CITY OF PATASKALA BOARD OF ZONING APPEALS

STAFF REPORT

Transportation Corridor Overlay District TCOD-22-002

TCOD-22-002 Staff Review

**PROVISION LIVING
CITY OF PATASKALA
DEVELOPMENT PLAN**

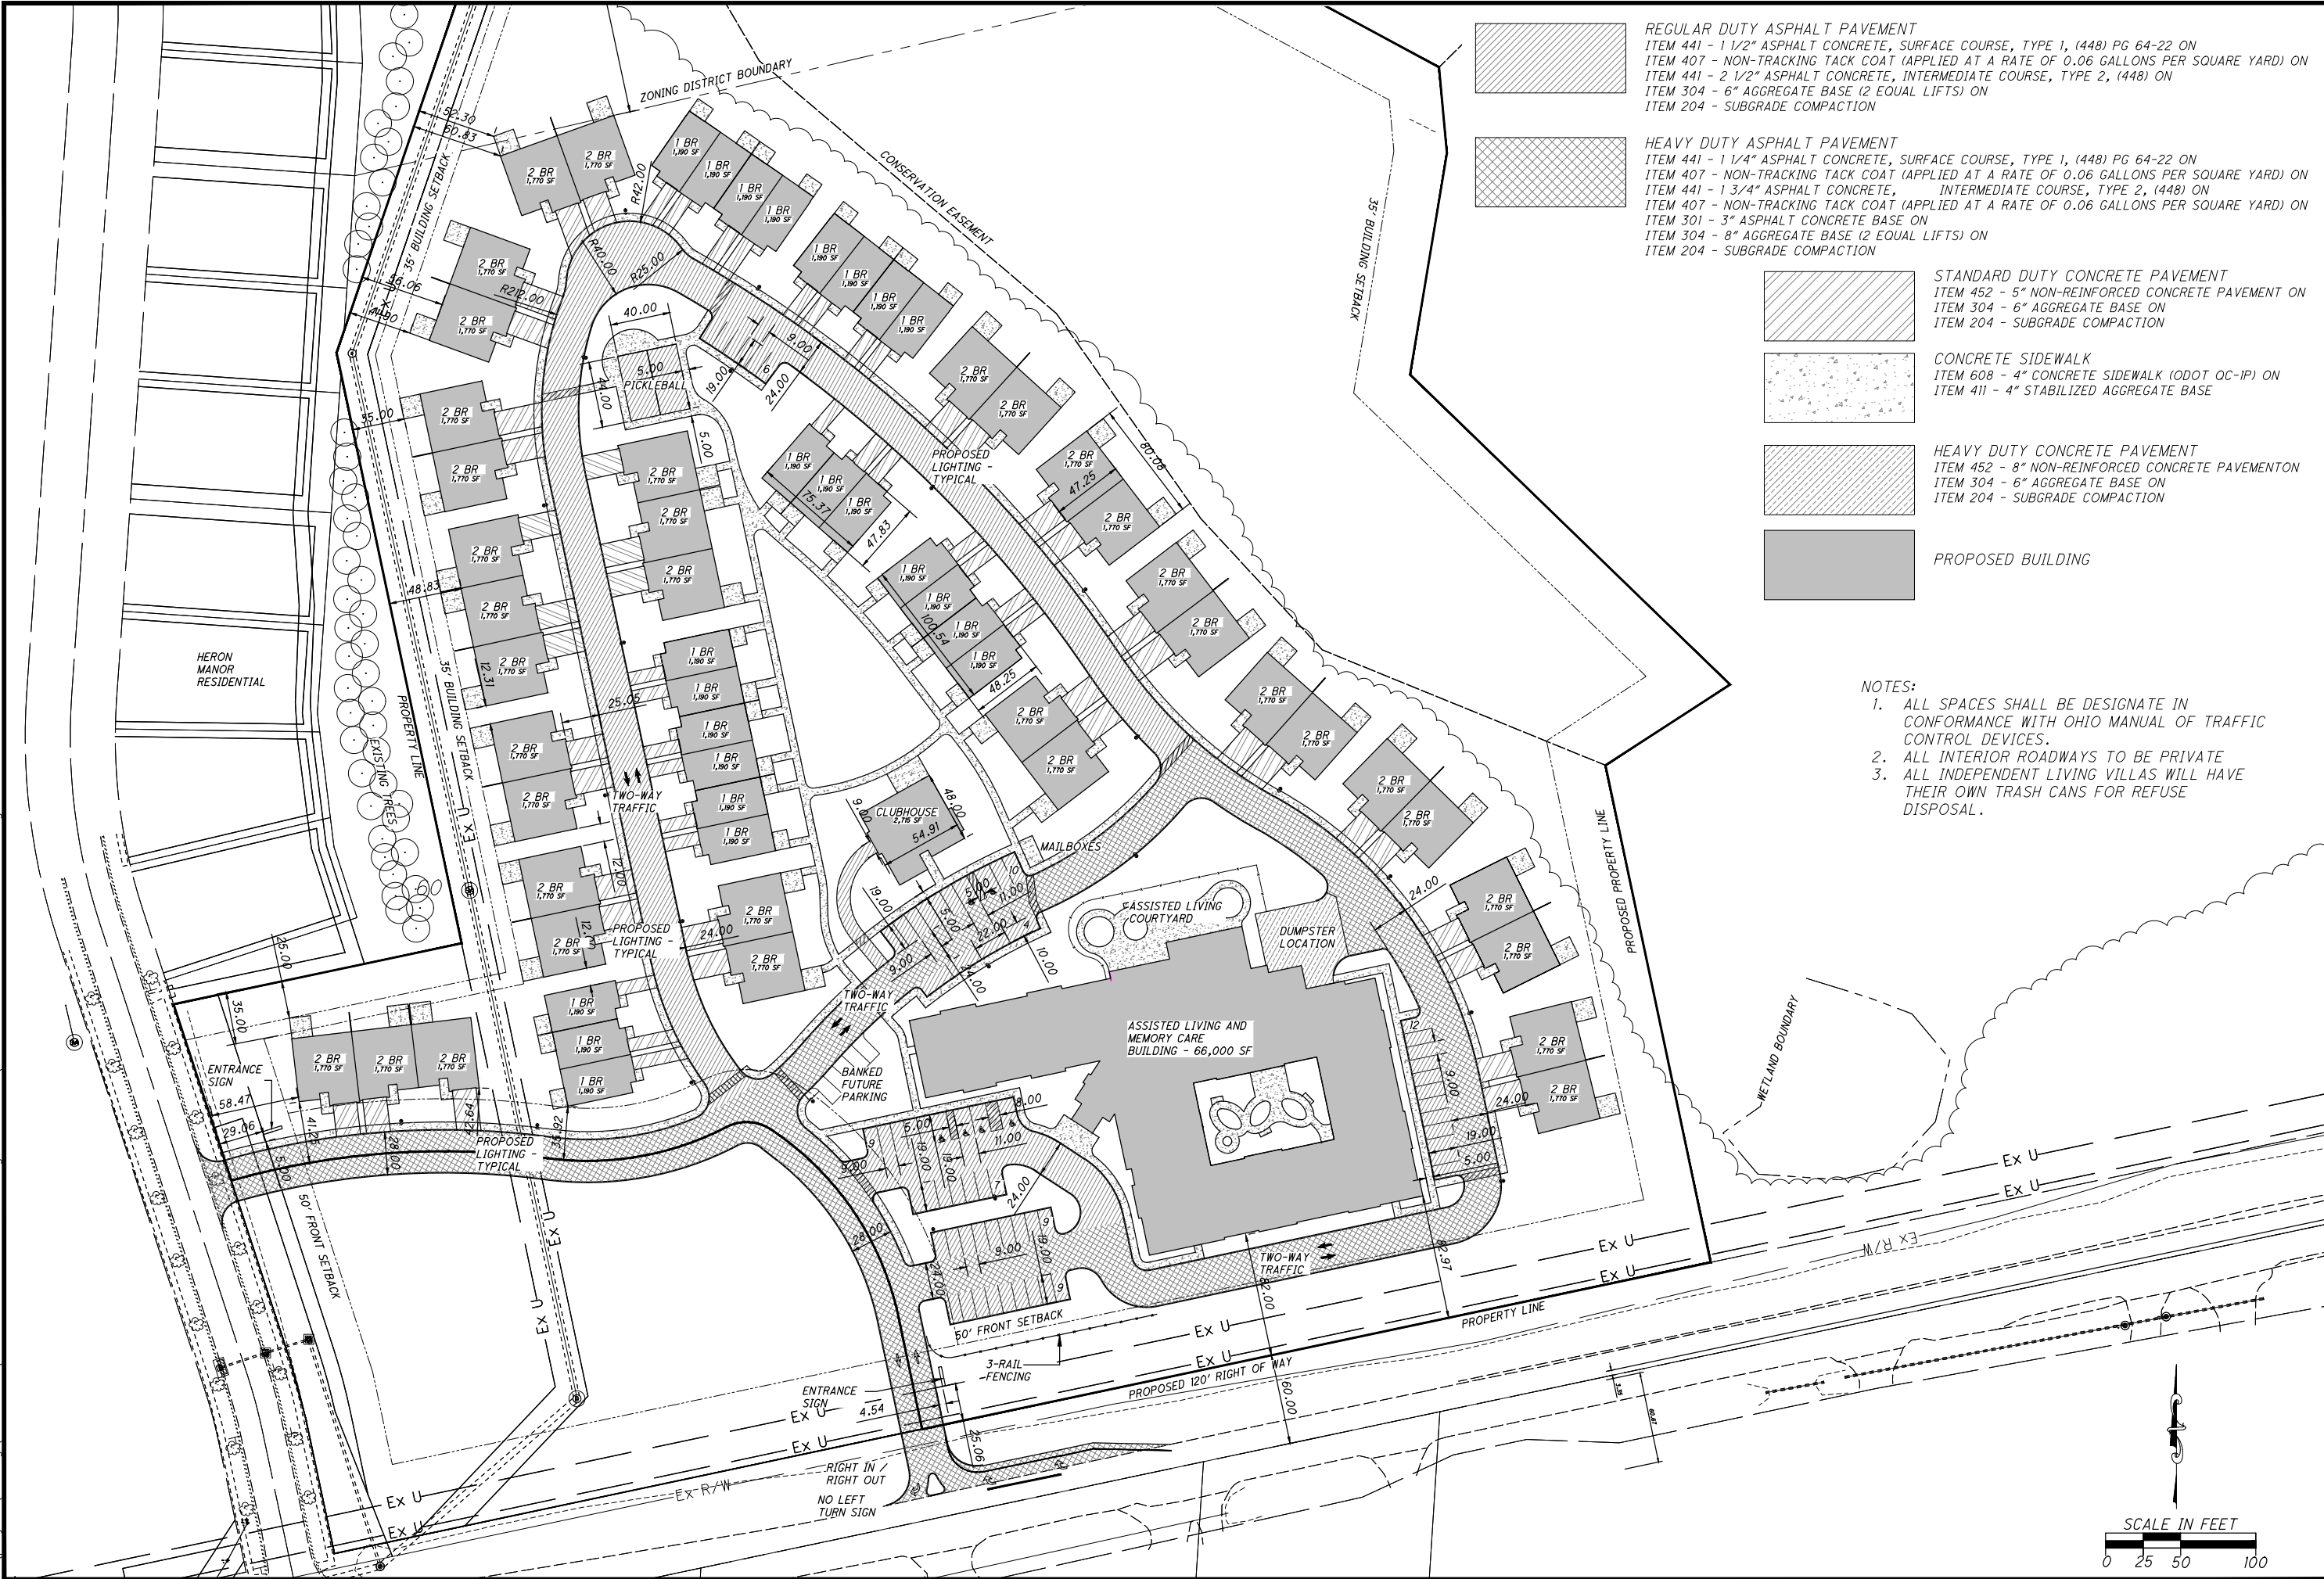
- ~~Why is dimension from westernmost ILV show at an angle to the rear of the structure? Should be shown from closest point of structure to closest property line.~~

- ~~On page 2: Only the ILV's on the east side of the site are labeled with bedroom numbers. Indicate the remaining.~~
 - ~~1259.06(2)(b): Traffic concept: All points of ingress and egress onto public roadways and the overall traffic distribution scheme shall be shown, indicating traffic flow patterns and traffic control points. The requirements for a traffic study and the need for "Traffic Safety Measures" shall be at the discretion of the City Engineer and approved, approved with modifications or disapproved by the Planning and Zoning Commission.~~

CITY OF PATASKALA NOTES:

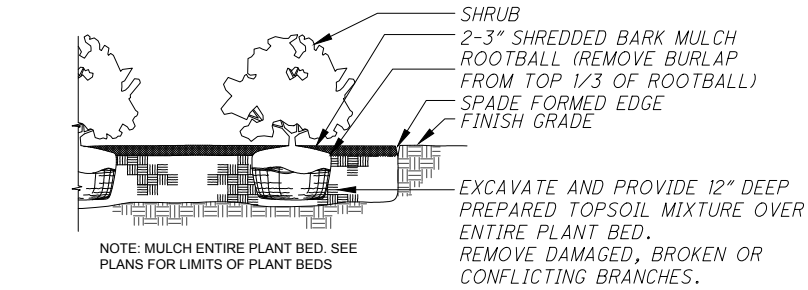
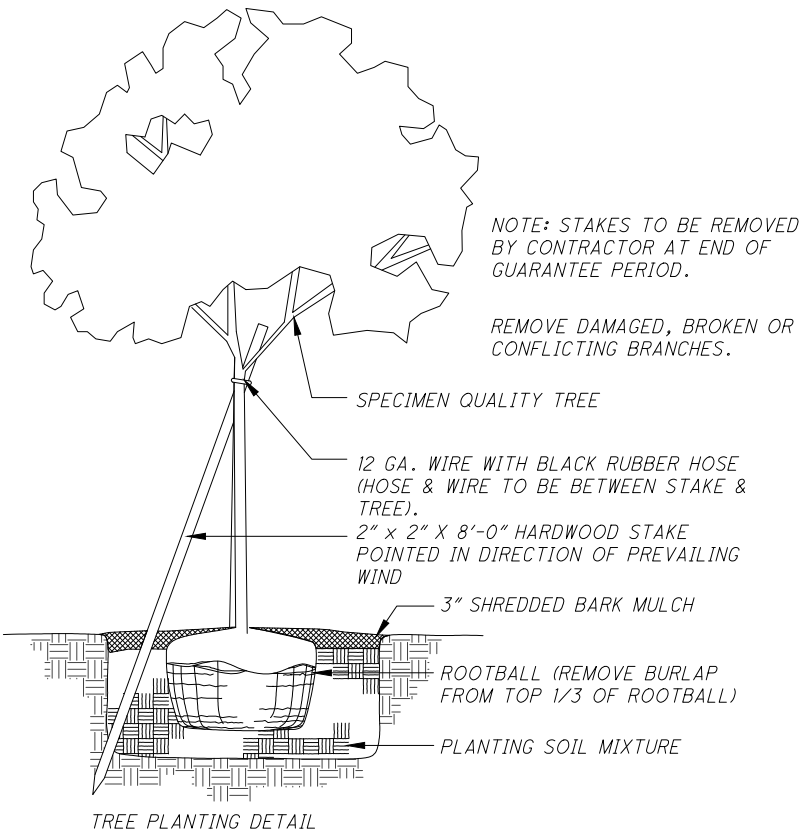
- ~~North: Mix of low shrubs and evergreen/deciduous trees along North side.~~
 - ~~Does not strictly meet L3 or L4, up to PZC to approve.~~
- ~~Within General Notes on Page 6/6, provide the following additional notes:~~

- ~~Changes and/or Substitutions, including but not limited to species or location, that deviate from the approved Landscaping Plan shall be approved by the Planning and Zoning Department prior to installation.~~

- CHANGES AND/OR SUBSTITUTIONS, INCLUDING BUT NOT LIMITED TO SPECIES OR LOCATION, THAT DEViate FROM THE APPROVED LANDSCAPING PLAN SHALL BE APPROVED BY THE PLANNING AND ZONING DEPARTMENT PRIOR TO INSTALLATION.
- LANDSCAPING SHALL BE MAINTAINED IN PERPETUITY.
- ALL SHRUBS SHALL BE MAINTAINED AT A MINIMUM OF THREE FOOT HEIGHT.

2 EXTERIOR ELEVATION - SOUTH
P3 3/32" = 1'-0"

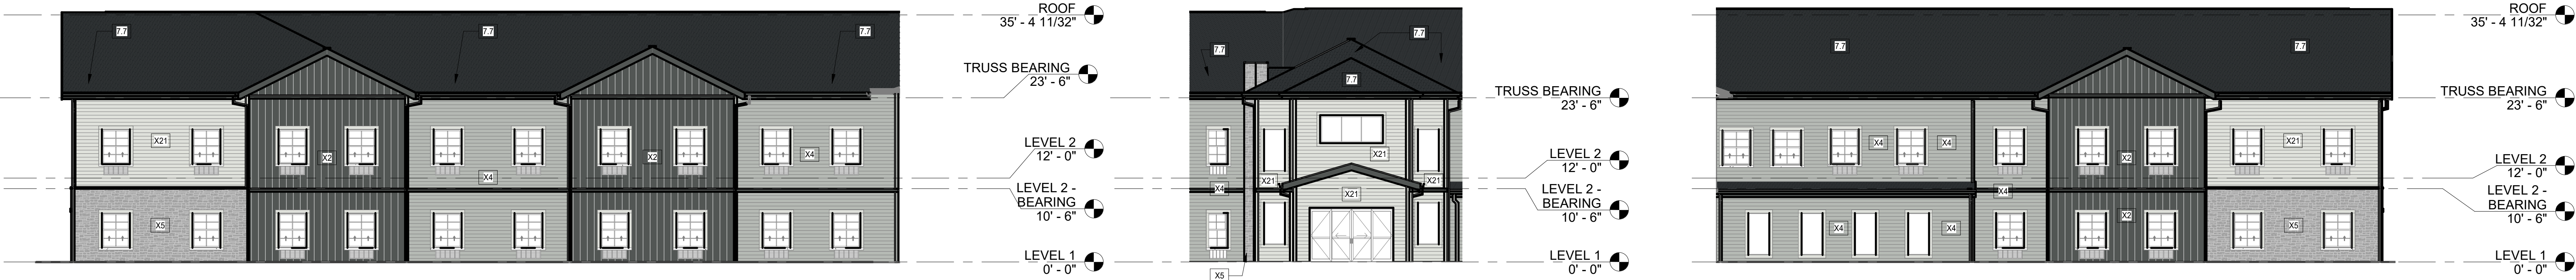
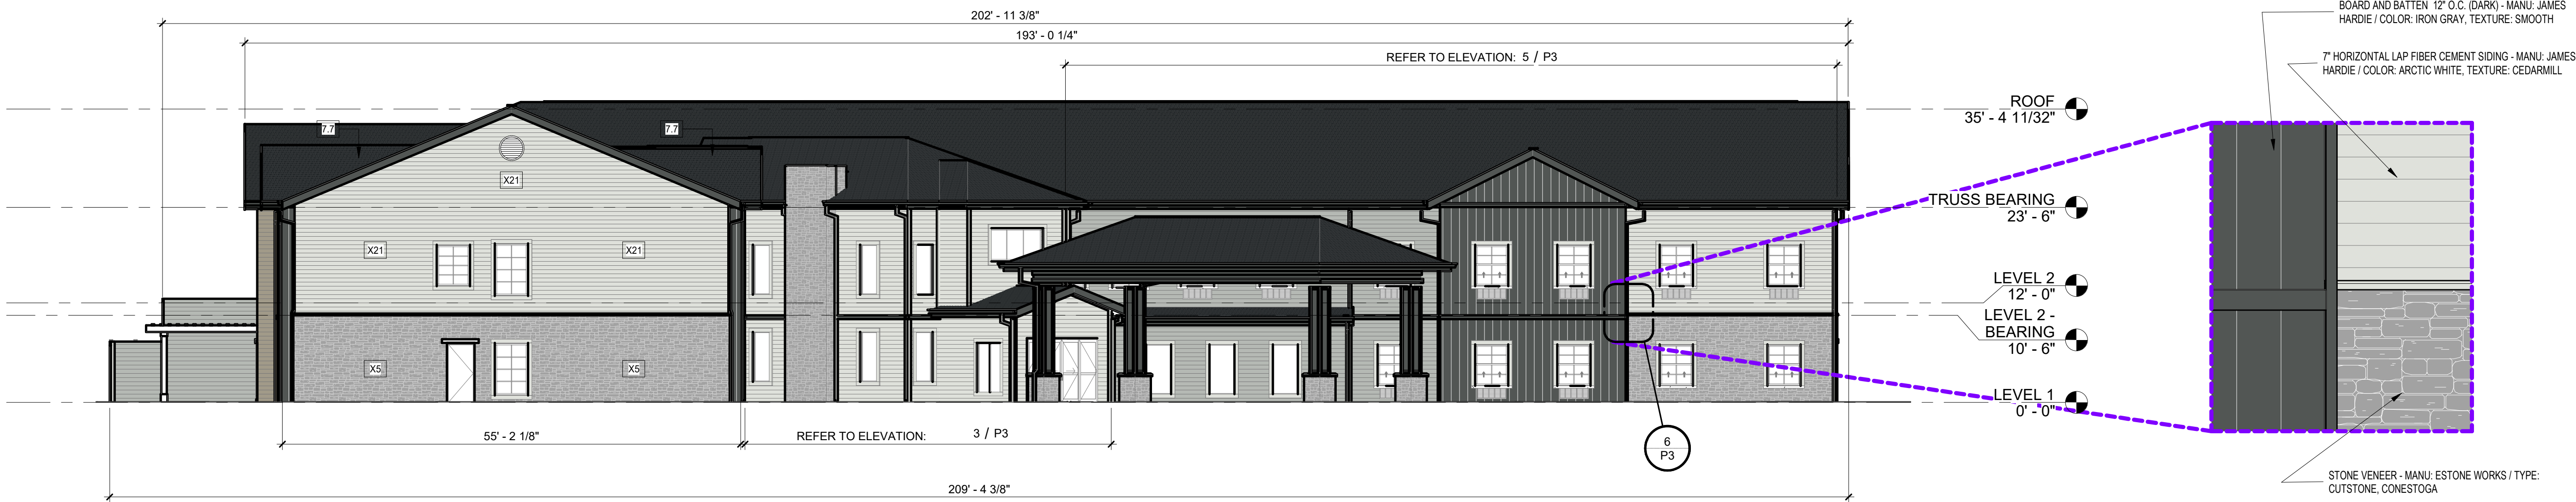
- The proposed building height exceeds the 35' maximum height permitted by Section 1249.05(A) by 4-11/32" The Planning and Zoning Commission is unable to approve as proposed, so a Variance will be needed.
- The Transportation Corridor Overlay District requires that sidewalk/paths shall be installed along each developed parcels frontage.
 - There are existing low-hanging overhead electric wires along the right-of-way of Broad Street. The City would prefer any pathway to be within the right-of-way, however, with the low-hanging wires being present, the City believes a fee-in-lieu would be appropriate for the development at this time.
- As this is a TCOD, per Chapter 1259, the Planning and Zoning Commission may approve, approve with modifications, or disapprove landscaping as proposed.

- Additional architectural detail added to the south side of the ALF building visible from Broad St. Added gables vents, horizontal bands, more stone, and more variety of colors and materials.

Villa Upgrades

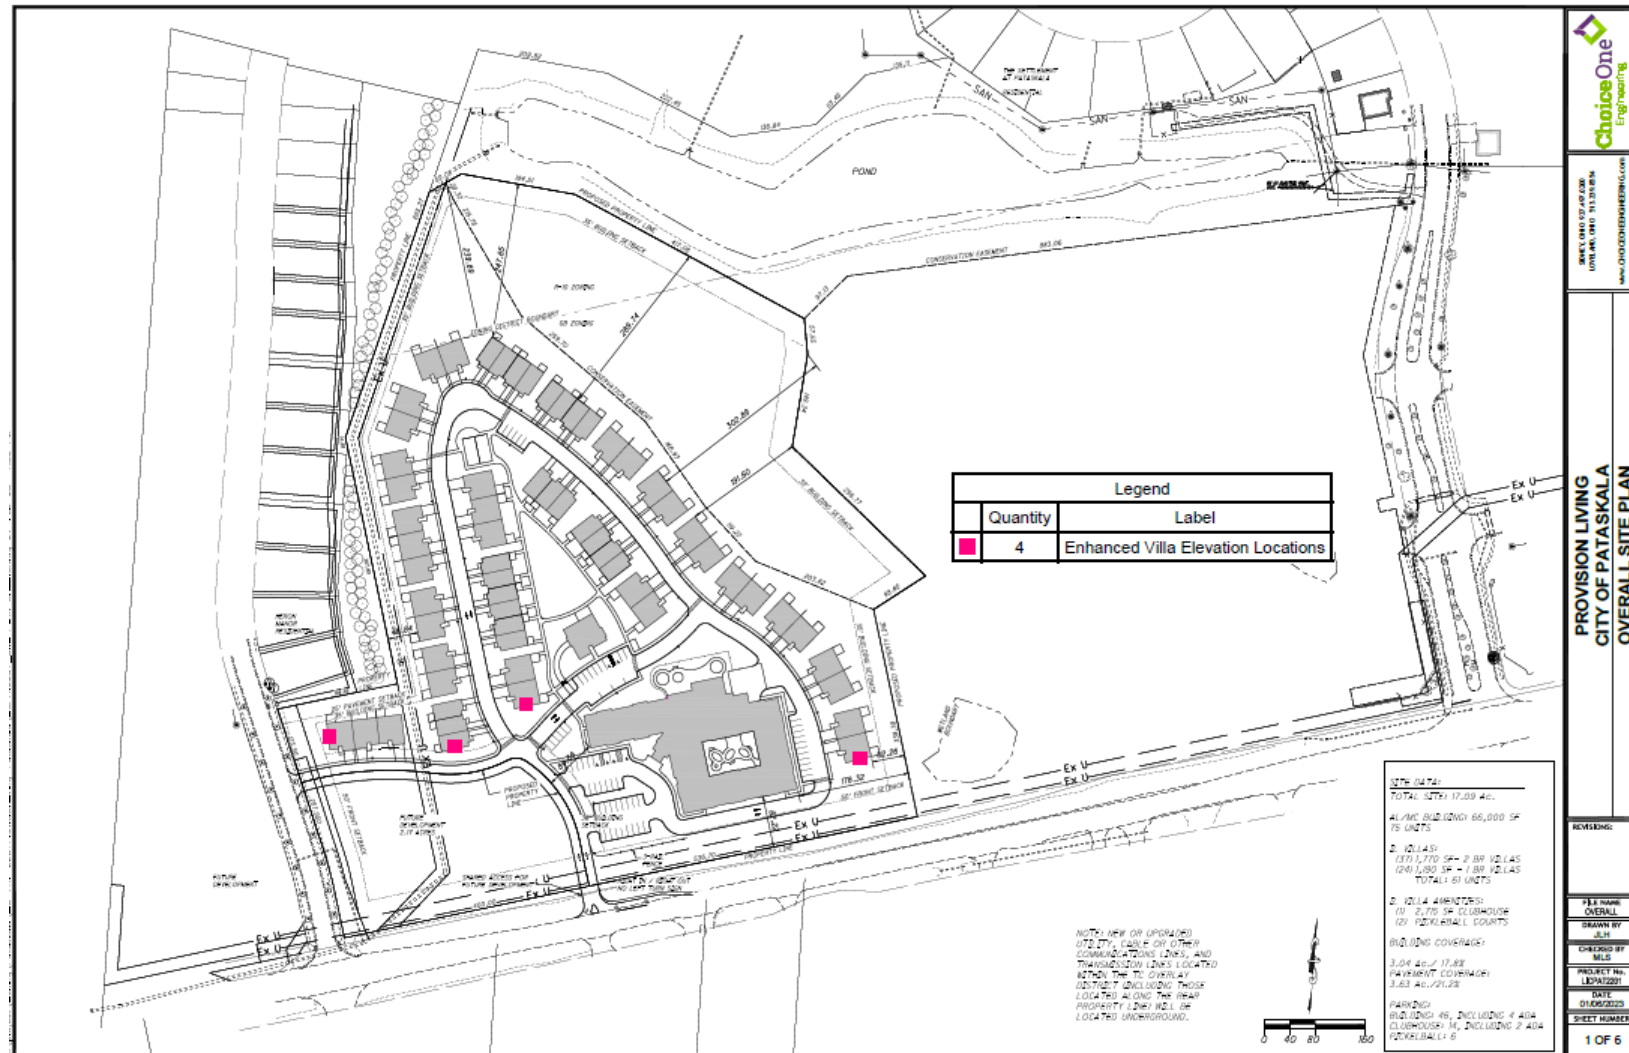
- ALF elevations include material specifications for better clarity.
- End-unit villas that are visible from Broad St. are enhanced with additional architectural detail.

Villa end-units that are most visible from the primary thoroughfares of Broad St. and Heron Ave., identified in pink below, will be enhanced with additional architectural detail. The representative elevations of enhanced units, shown below, include two or more styles or colors of materials separated by a gables band.
